**CITY OF EL PASO, TEXAS  
AGENDA ITEM  
DEPARTMENT HEAD'S SUMMARY FORM**

# CITY OF EL PASO CONSTRUCTION CHANGE ORDER

CONSTRUCTION CHANGE ORDER NO.: 7      DATE: August 15, 2011       SCOPE CHANGE  
 PROJECT: International Bridges - Stanton Toll Facility and Paso Del Norte      SOLICITATION NO. 2010-170       CONSTRUCTION CHANGE

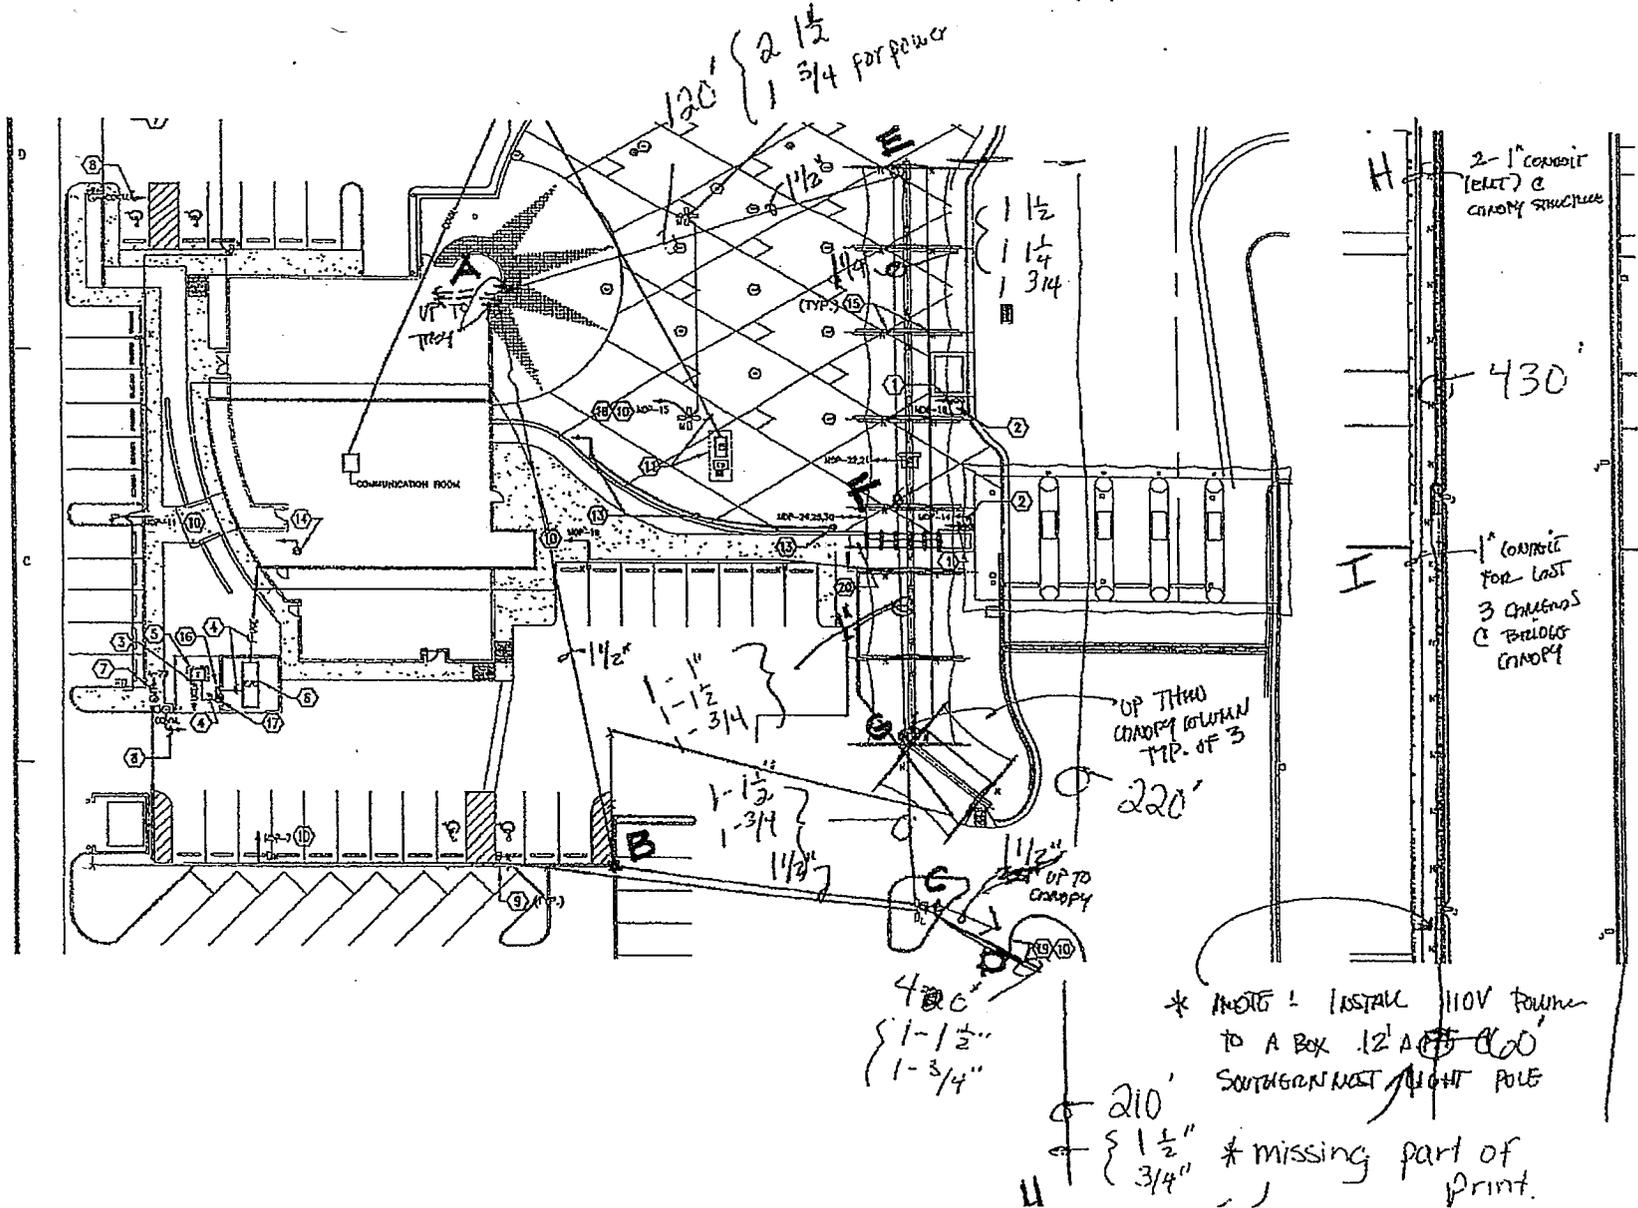
Project No. & Name: Stanton Toll Facility Date: 4/8/20011  
 Contractor Name: Urban & Associates Change Proposal No. RFP STN 012  
 Description of Change: Change to electrical sheets

Code	Description	Quantity	Hours	Unit Cost	Labor	Material & Equipment	Total
STN 012							
Install bridge canopy security camera infrastructure as described in RFP STN 12 and shown in sketch							
	From A to E 2- 1 1/2" PVC SCH 40	240 feet	20	6.19	\$ 1,950.00	4,445.60	
	1 3/4" PVC SCH 40	120 feet	8	6.64	\$ 780.00	796.80	
	3 #10 THHN wires	360 feet	4	0.67	\$ 390.00	241.20	
	Trenching	120 feet	4	2.40	\$ 390.00	30.00	
	Backfill and compacting	20 180 cu. yd	15	20	\$ 1,462.50	180.00	
	From E to F 1- 1 1/2" PVC SCH 40	100 feet	8.5	6.19	\$ 828.75	619	
	1- 1 1/4" PVC SCH 40	100 feet	7	5.06	\$ 682.50	506	
	1- 3/4" PVC SCH 40	100 feet	6.5	6.64	\$ 633.75	664	
	3 #10 THHN wires	300 feet	3.5	0.67	\$ 341.25	261	
	Trenching	100 feet	3.5	2.40	\$ 341.25	21.60	
	Backfill and compacting	17 150 cu. yd	13	20	\$ 1,267.50	150.00	
	From F to G 1- 1 1/2" PVC SCH 40	80 feet	7.5	6.19	\$ 731	495.20	
	1- 1" PVC SCH 40	80 feet	5	4.38	\$ 488	350.40

\* NOTE: INSTALL ONE REGISTER BOX  
PER (2) 90° BENDS MAX.

\* NOTE: INSTALL 110V POWER  
TO A BOX 12' AWAY FROM  
SOUTHGATE LIGHT POLE

Request for Proposal: STN-012

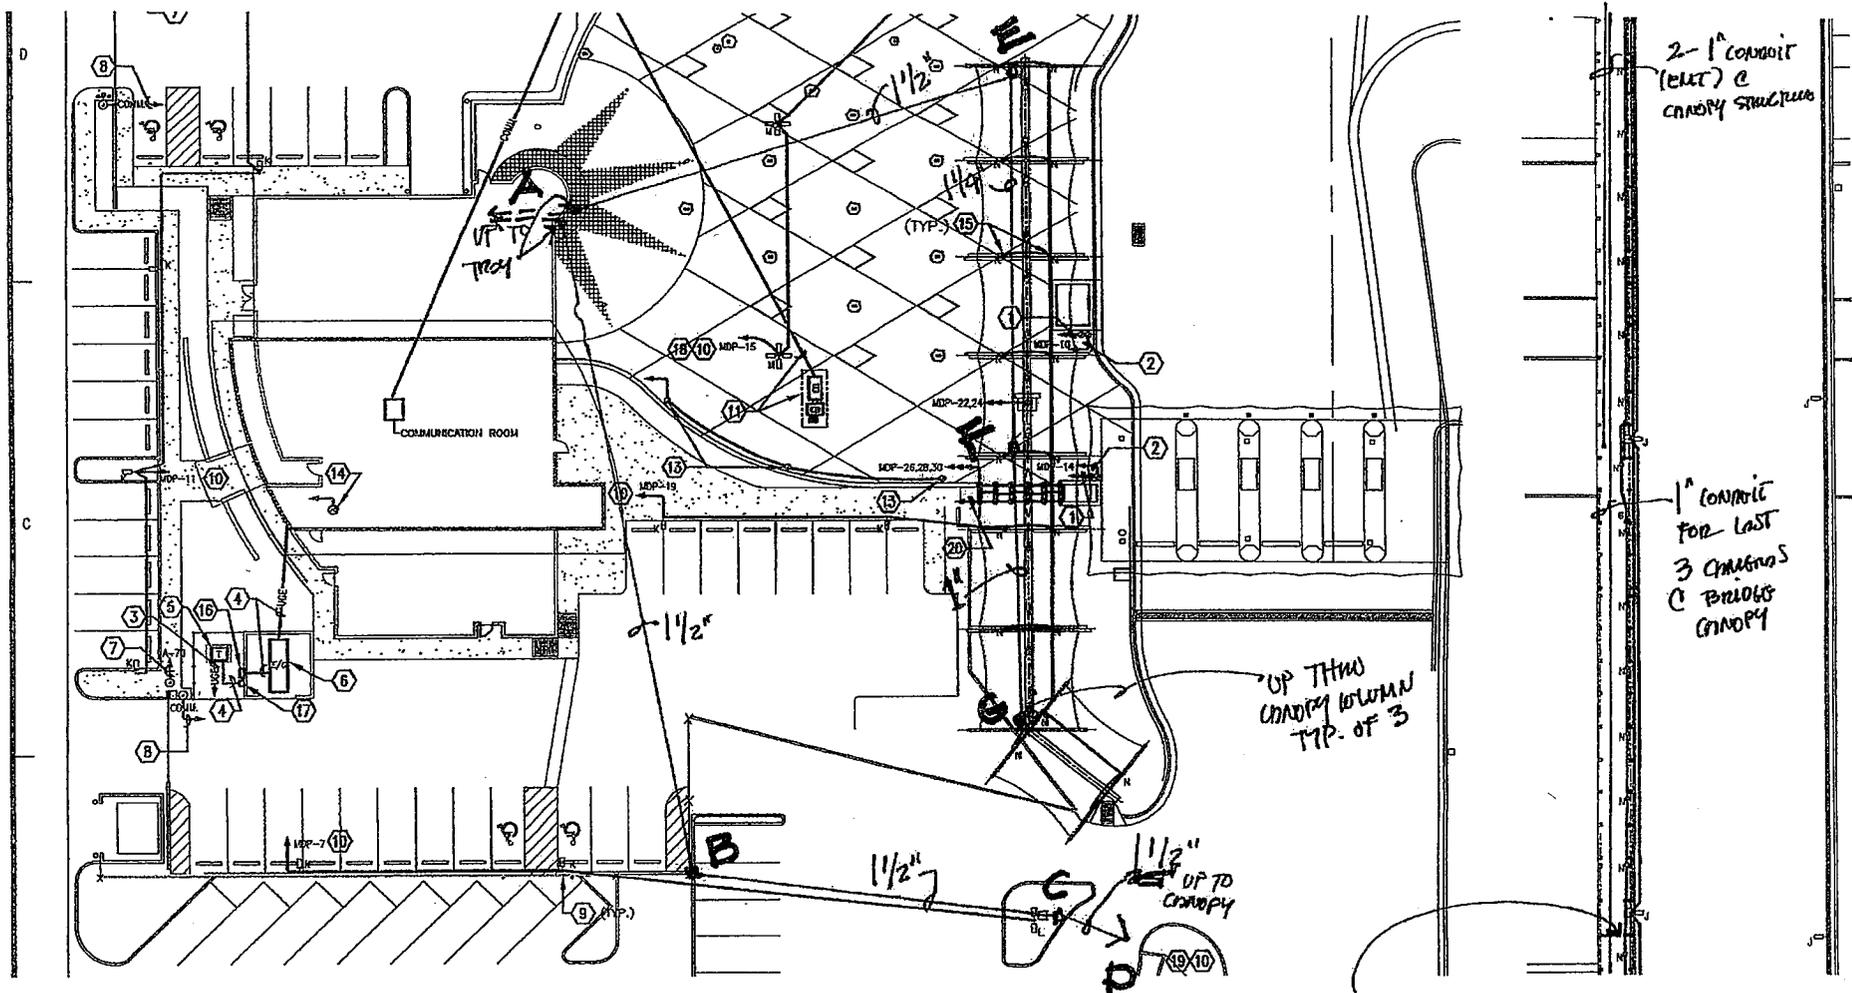
- Provide price to install bridge canopy security camera infrastructure as described below & shown in the attached sketch:
  - Install 1 1/2" conduit over the proposed ceiling from cable tray located above Corridor Room No. 102 to outside sleeve at concrete canopy marked "A",

- From outside sleeve at "A", attach 1 1/2" conduit to outside face CMU wall down to a new Ground Pull Box,
  - From the new Ground Pull Box mentioned in item 1b) above, install a 1 1/2" underground PVC conduit to a new Ground Pull Box at "B" where it meets the electrical trench made for the Light Fixtures,

- From this new Ground Pull Box at "B", install a 1 1/2" PVC conduit in the same trench as electrical power conduits (separate camera conduit by 6" dirt) to "C" to new Ground Pull Box,

- From the new Ground Pull Box at "C", install a 1 1/2" underground PVC conduit to new Ground Pull Box at "D" at the base of the Northernmost fabric canopy column at the base of the Bridge,

- From new Ground Pull Box at "D", install a 1 1/2" EMT conduit up the column of the fabric canopy to a new register box,
  - From that last register box at the fabric canopy structure, install two (2) 1" EMT conduits, one will go halfway up the bridge canopy and the second will go up the entire length of the bridge canopy. A total of six (6) cameras will be installed at the bridge canopy (three per EMT conduit).

- Provide price to install Plaza security camera infrastructure as described below & shown in the attached sketch:
  - Install 1 1/2" conduit over the proposed ceiling from cable tray located above Corridor Room No. 102 to outside sleeve at concrete canopy marked "A",

- Provide price to install 110V power to an electrical box located 12' A.F.F. on the southernmost new street light pole on the West side of the bridge only.

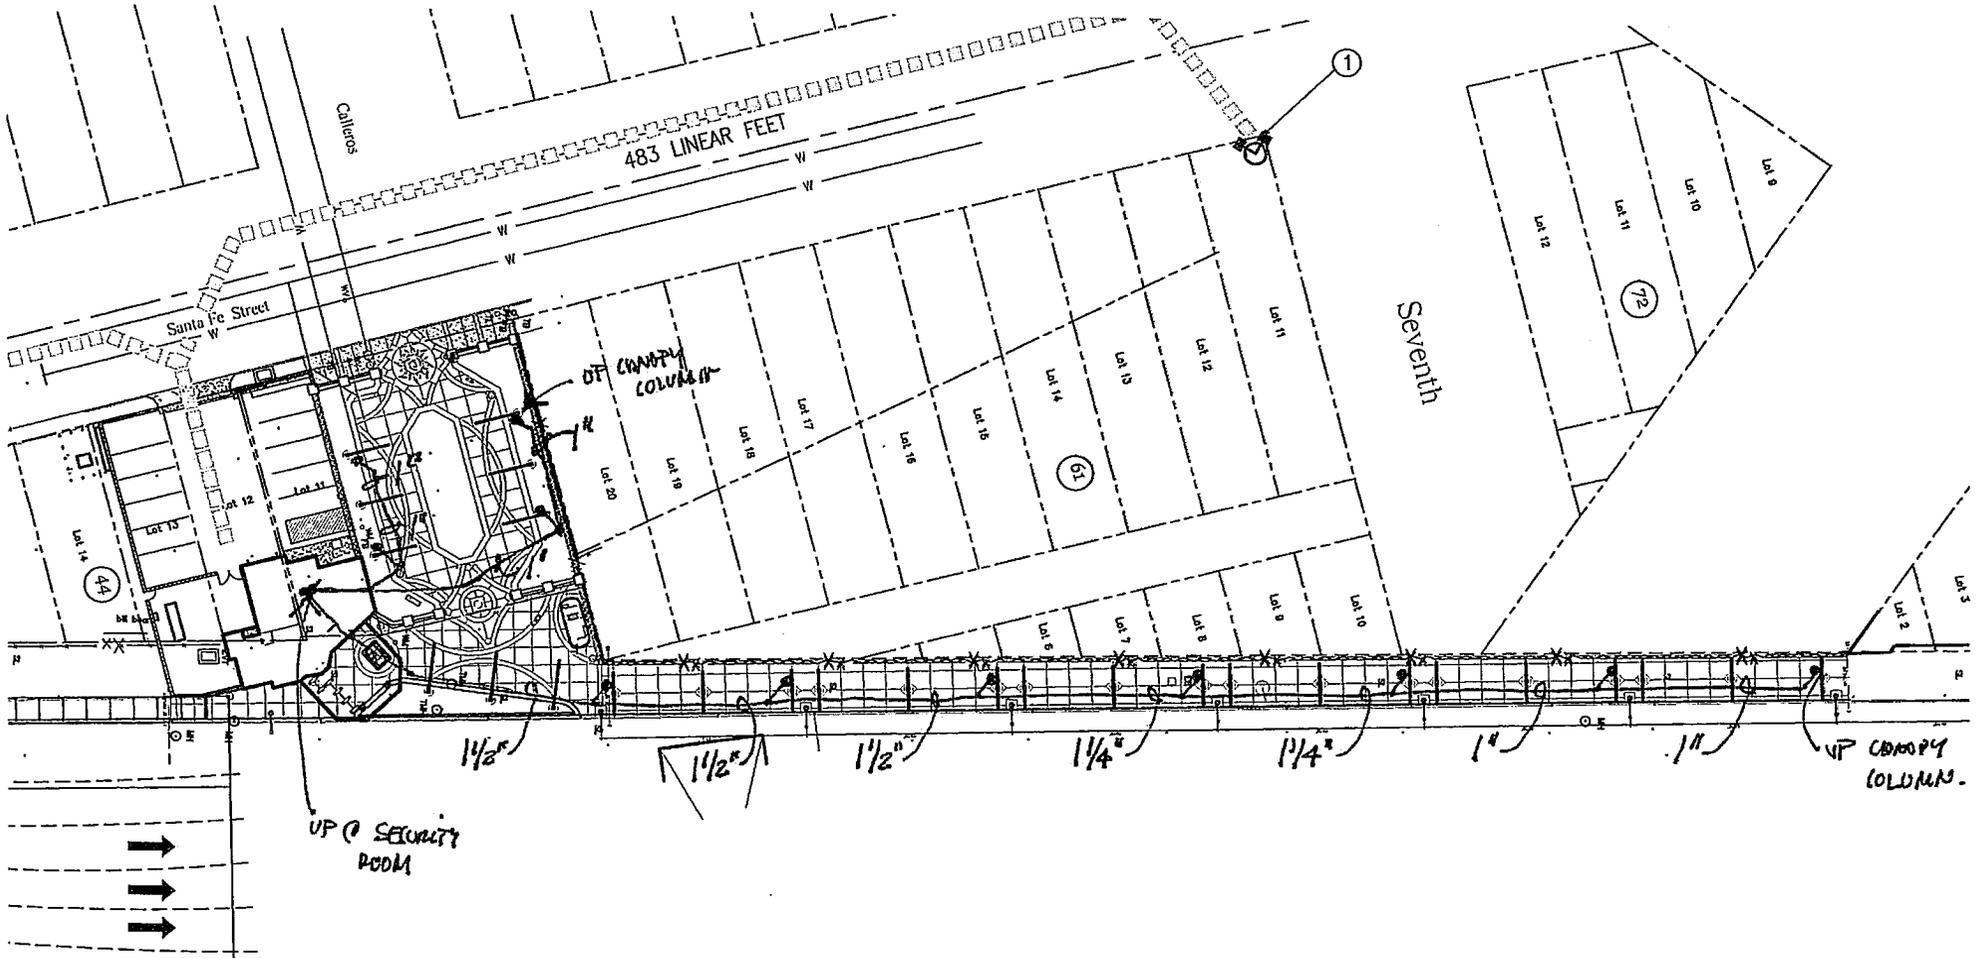
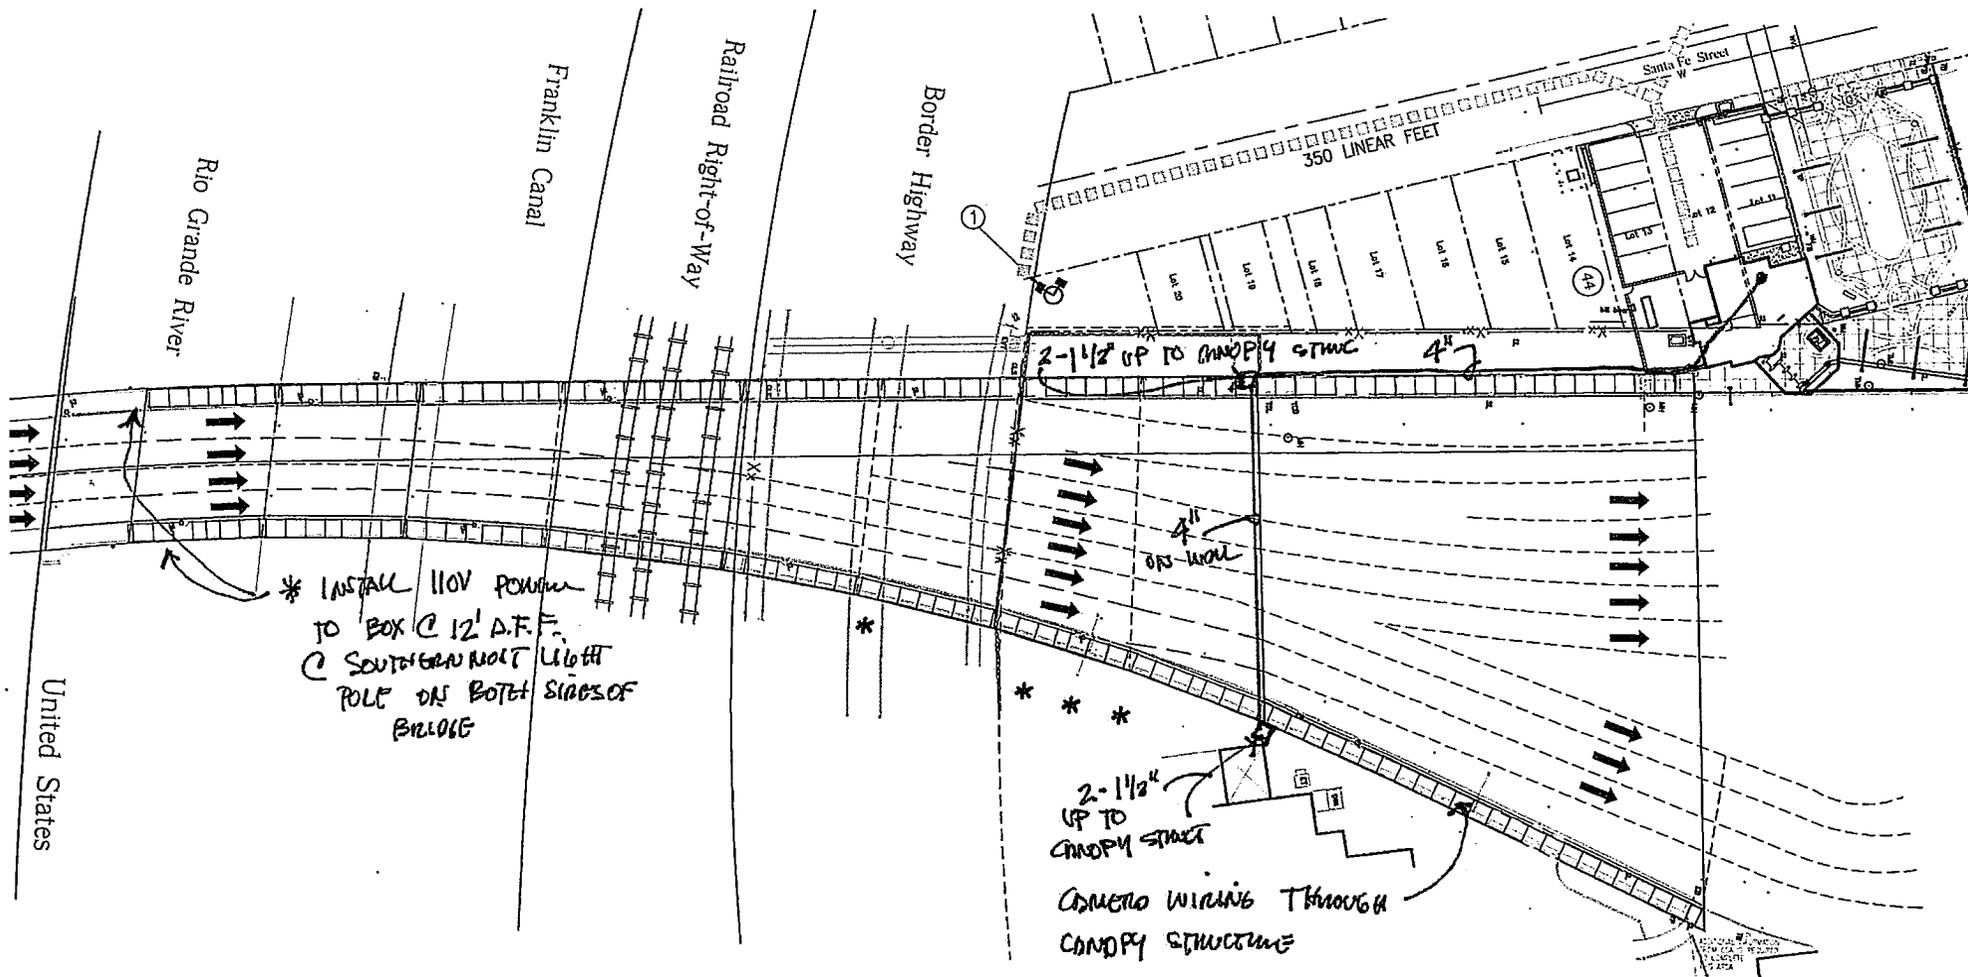
- Provide price to install Bridge Canopy security camera infrastructure as described below and in attached sketch:
  - Install 4" PVC conduit underground from Security Equipment/IT Room No. 105 to South side of existing rock wall at Bridge abutment to a register box,

- From the last register box described in item b) above, install a 2" EMT conduit up the Bridge East wall to the pedestrian canopy structure .
- Provide price to install 110V electrical power to a box attached to the southernmost new Street Light Pole at 12' A .F.F. on both sides of the Bridge.

- Provide price to install four (4) 1" diameter conduits up through the Placita fabric canopy columns as shown on attached sketch and as discussed with Ted Traffansted.

- Provide price to install six (6) 1" conduits up through the South El Paso sidewalk fabric canopy columns, one at each street light pole location as discussed with Ted Traffansted. Underground PVC conduit sizes per attached sketch.

**Request for Proposal: STN-035** **Date: 6/10/2011**

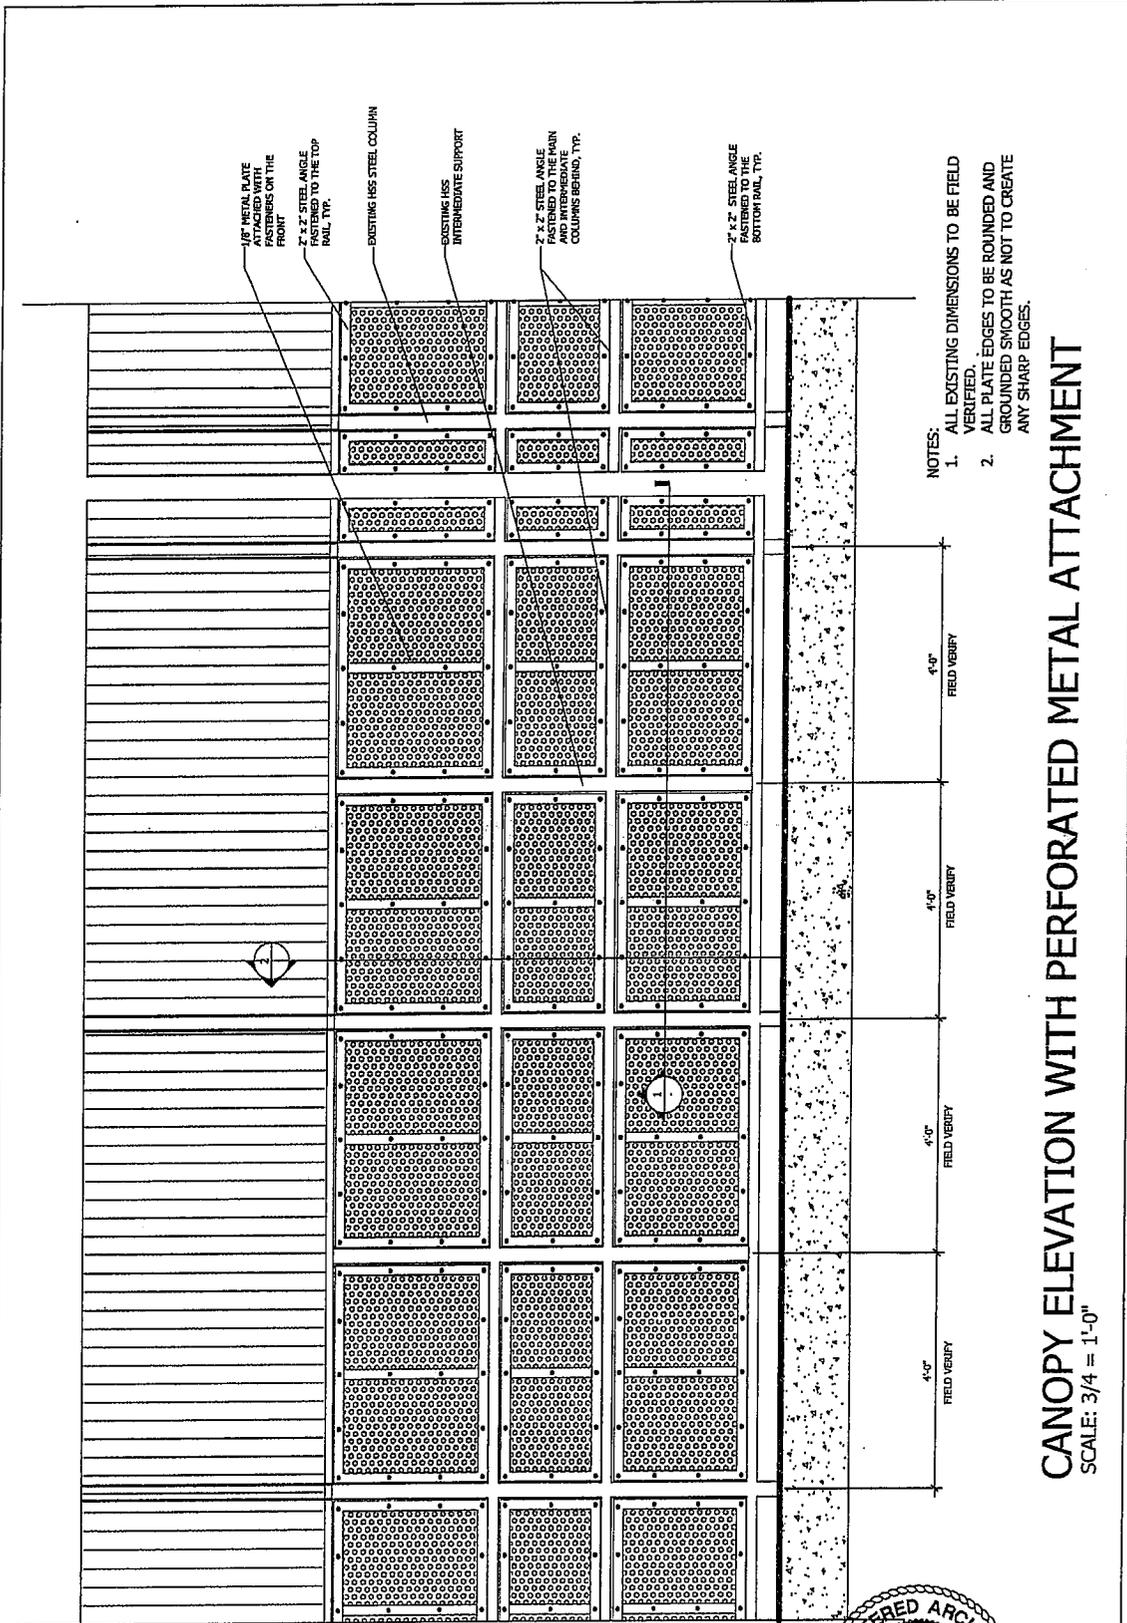
**Notes**  
Provide a price to install additional steel angles and plates to attach the Stainless Steel Perforated Metal panels in the bridge pedestrian canopy as shown in the attached SKA drawings and as approved in the mockup during the 5/31/2011 visit to El Paso Machine & Steel shop.
